UNITED STATES PATENT AND TRADEMARK OFFICE

Office Action Summary

10/693,355

DETAILED ACTION

**Fig 3**

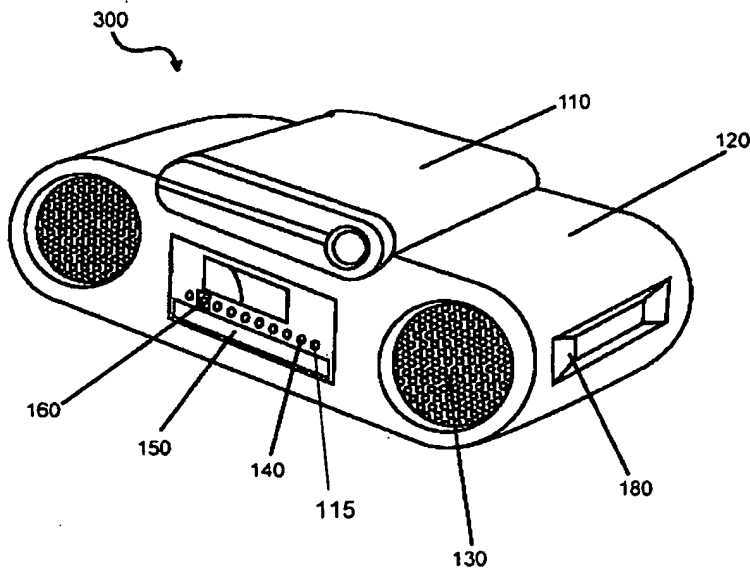
Applicant proposed herein to amend Fig. 3 to add reference number "115" and a reference line indicating an illustrated "indicator" as being element "115." Revised Fig. 3 is shown below. Additionally, a replacement drawings sheet is filed herewith. Approval of the proposed drawing change is respectfully requested.

Fig. 4

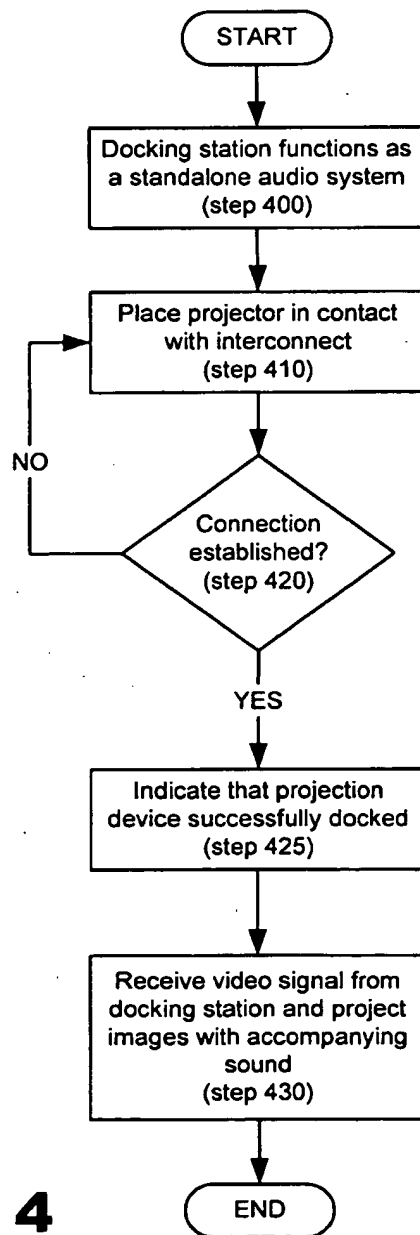
Applicant further proposes to amend Fig. 4, as shown below, to add step 425 "Indicate that projection device successfully docked" and to change step 430 to add the indicated language: "Receive video signal from docking station and project images with accompanying sound (step 430)." A replacement sheet bearing the amended Fig. 4 is also filed herewith.
